651S-1
GENERAL PURPOSE HF RECEIVER

PUB NO.	NOTE	DATE	SUBJECT
IB 1-72 ✓		03/01/72	Subassembly Interchangeability
SB 1		10/01/72	Reduction of 450-kHz Leakage From Synthesizer Reference Board All
SB 2		06/06/73	Reduction of Noise Level
SB 3		07/15/73	Add Keep-Alive Frequency Memory Function
SB 4		07/15/73	Extend Comma and Decimal Lamp Life in Frequency Display
SB A ✓		11/01/73	Change DCFE Filter Switching Diode
SB 5	1	12/15/74	Minimize TCU Circuit Card Response to Data Link Noise and Failure
SB 6	2	03/01/75	Reduce Intermodulation Level
SB 7		02/07/75	Reduce Internal Spurious Signals
SB 8		12/27/74	Allow Remote Control Operation With RS-232C Serial Control Interface Card A9
SB 9 ✓		02/15/75	Increase Life of Display Tubes
SB 10 ✓	2	12/31/75 Revised 08/02/76, 04/01/77	Replacing Display Tubes With LED Plug-in Assemblies
SB 11		Not issued	
SB B ✓		11/15/74	KAV
SB C ✓		01/15/78	Supply KAV Power to DCFE
SB 12 ✓		05/01/78 Revised 07/01/78	Replacing Nonprocurable Integrated Circuits

SERVICE BULLETIN A

SUBJECT: Change DCFE Filter Switching Diode

651S-1/1A Chassis, Partial Schematic Diagram
Figure 2

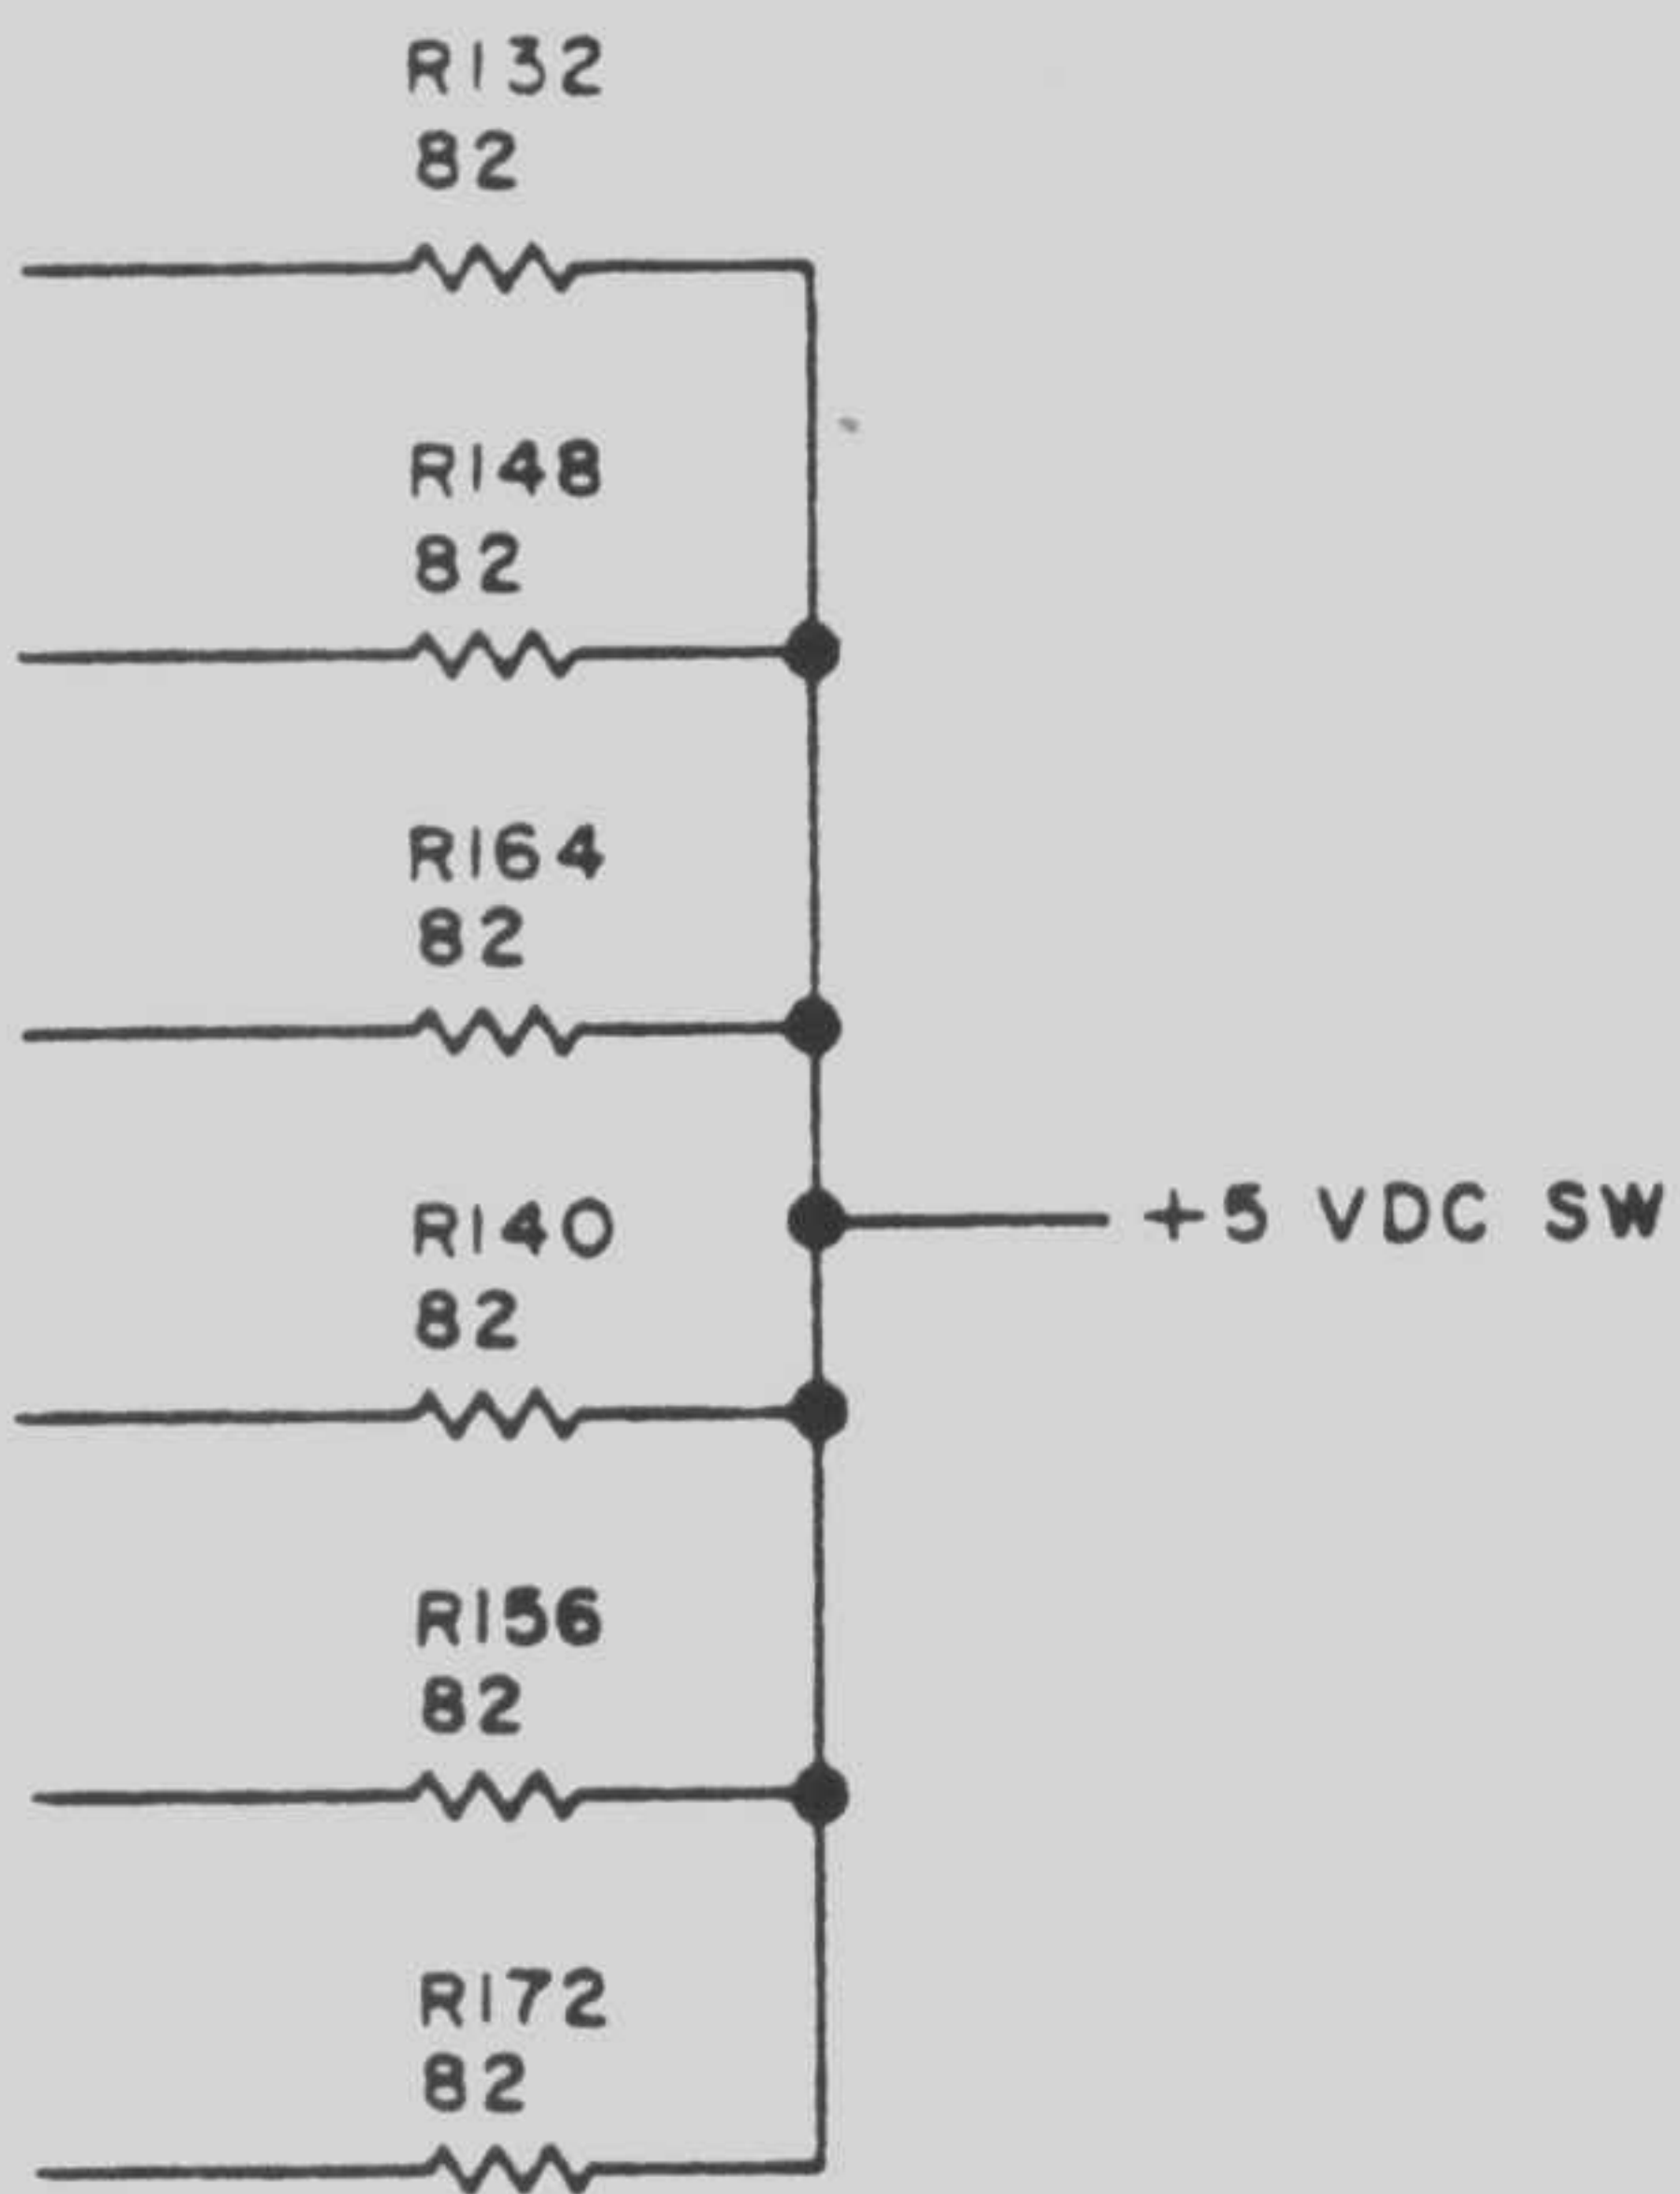
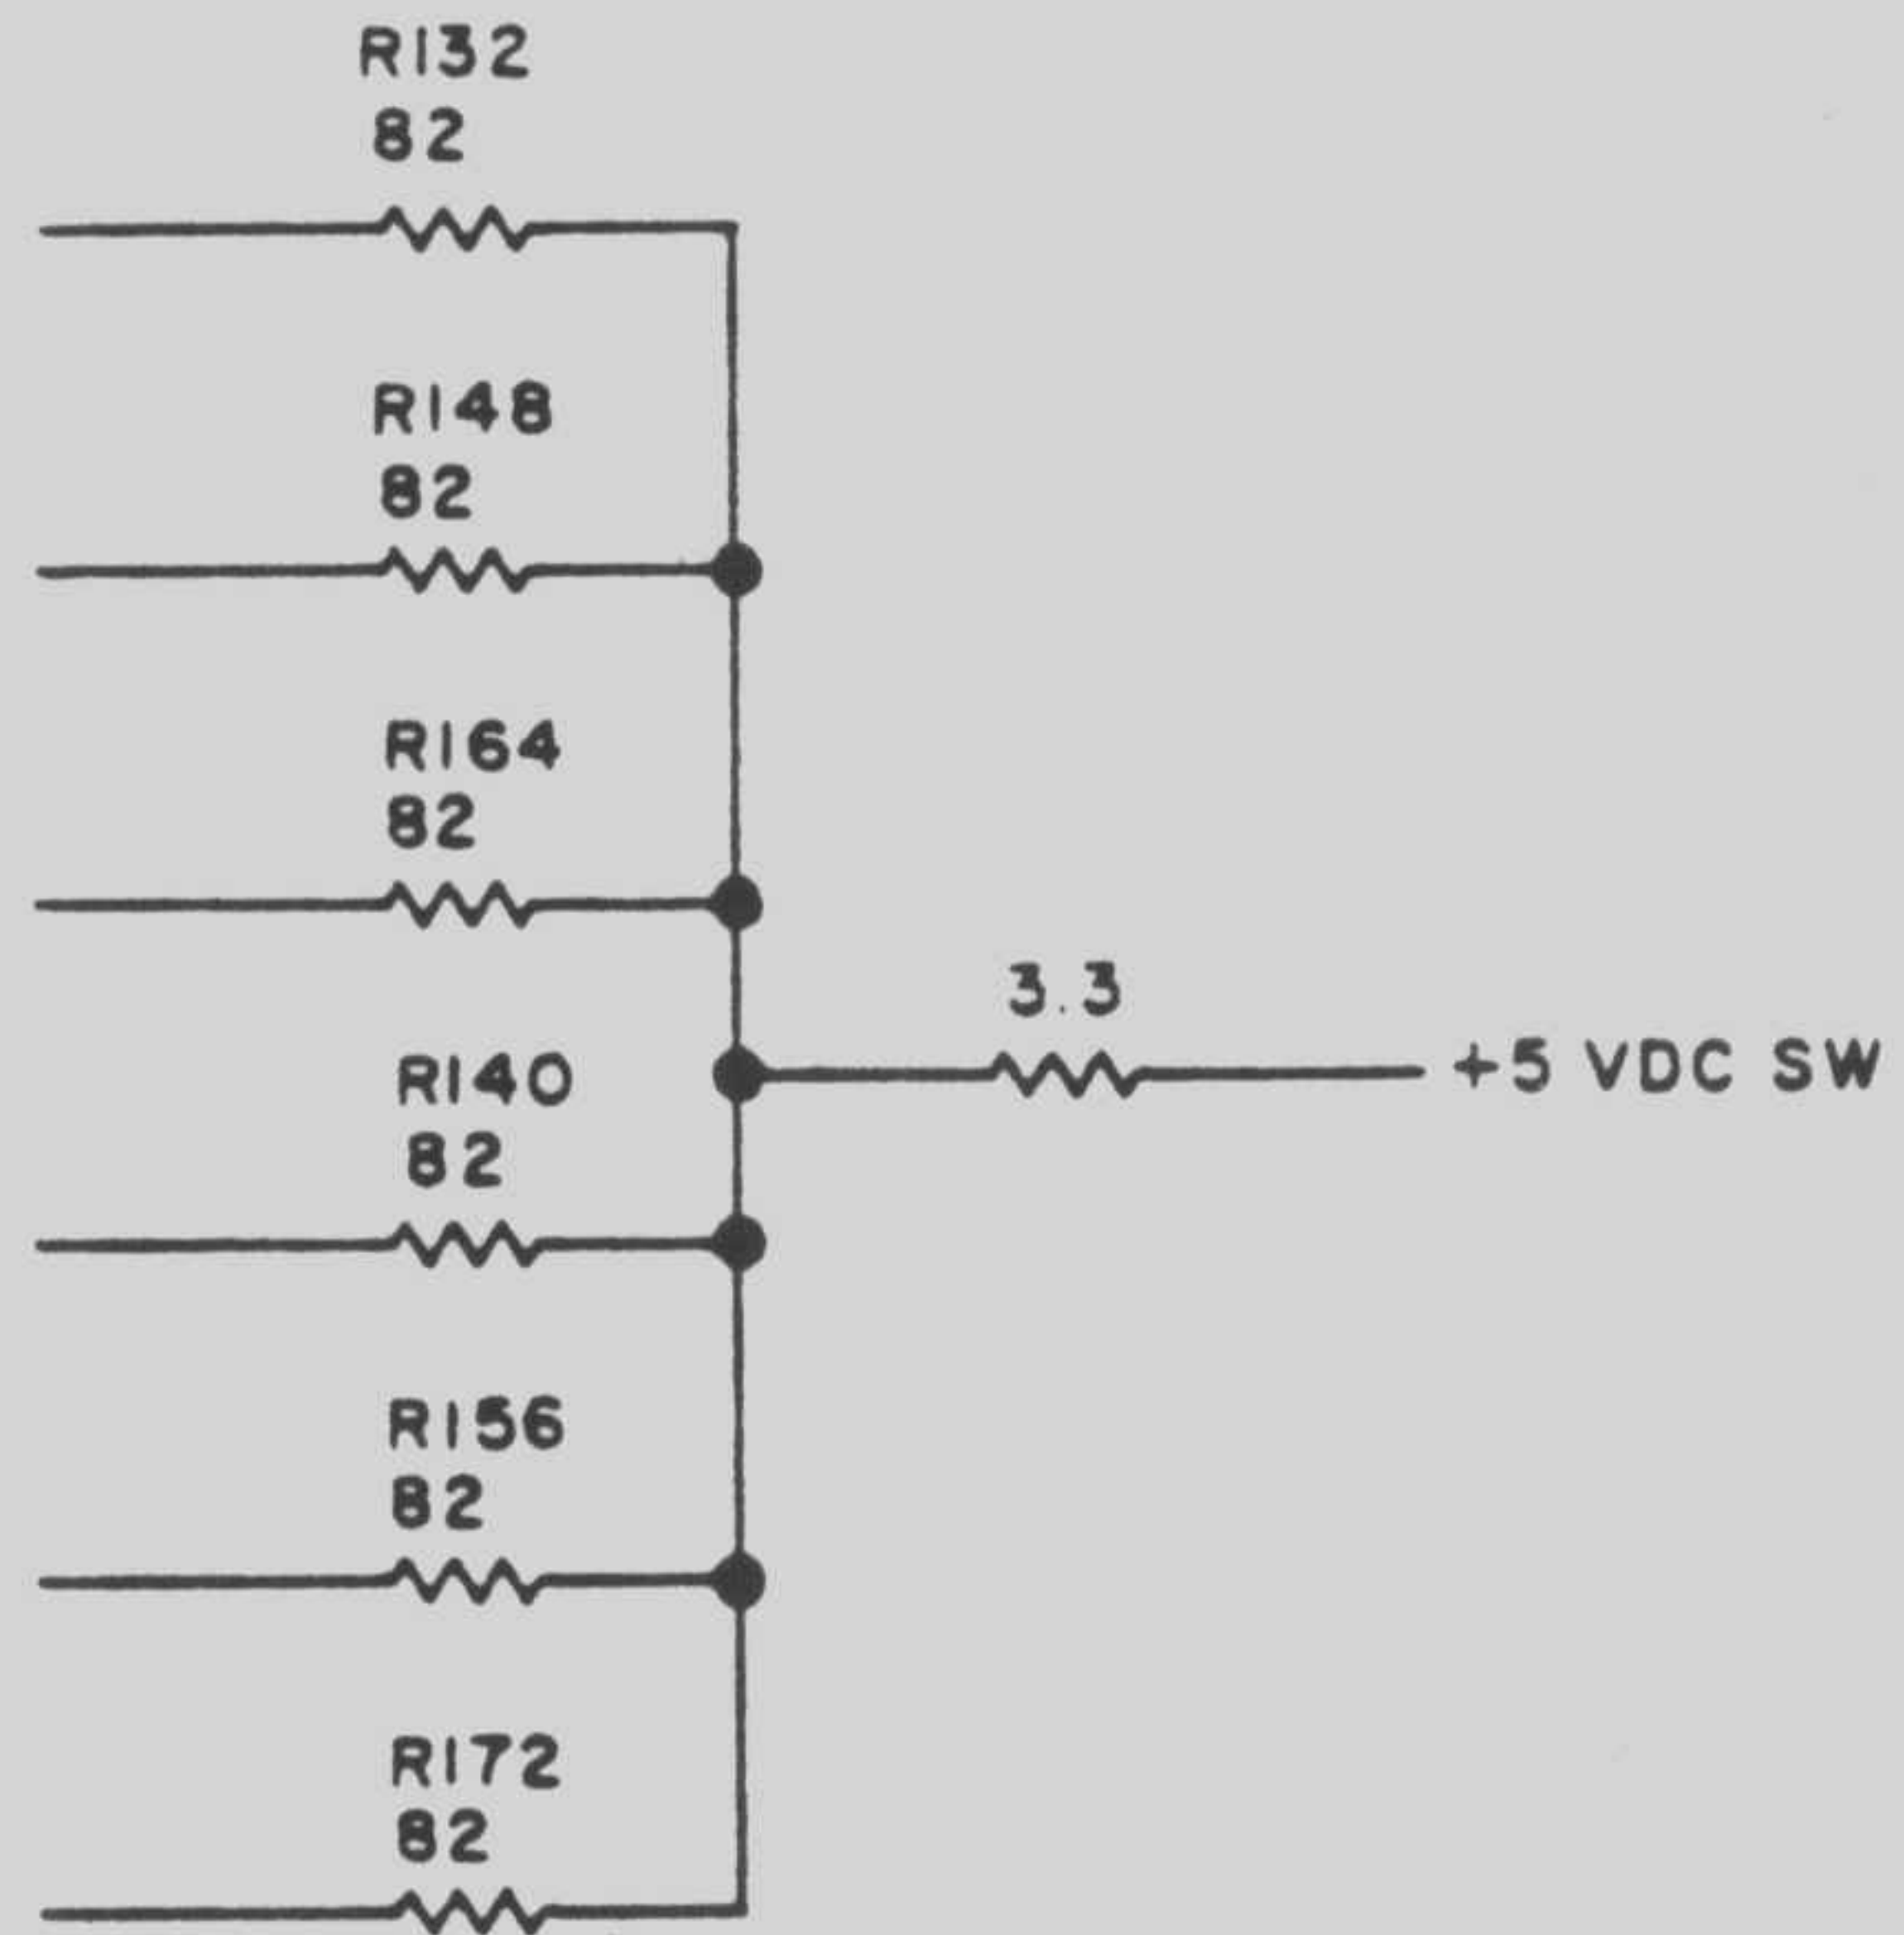
The modification consists of moving a wire and installing a resistor. This accomplishes the same result as the production revision, which changes the values of R132, R140, R148, R156, R164, and R172 from 82 to 100 ohms.

NOTE: Refer to figure 2 for the schematic modifications.
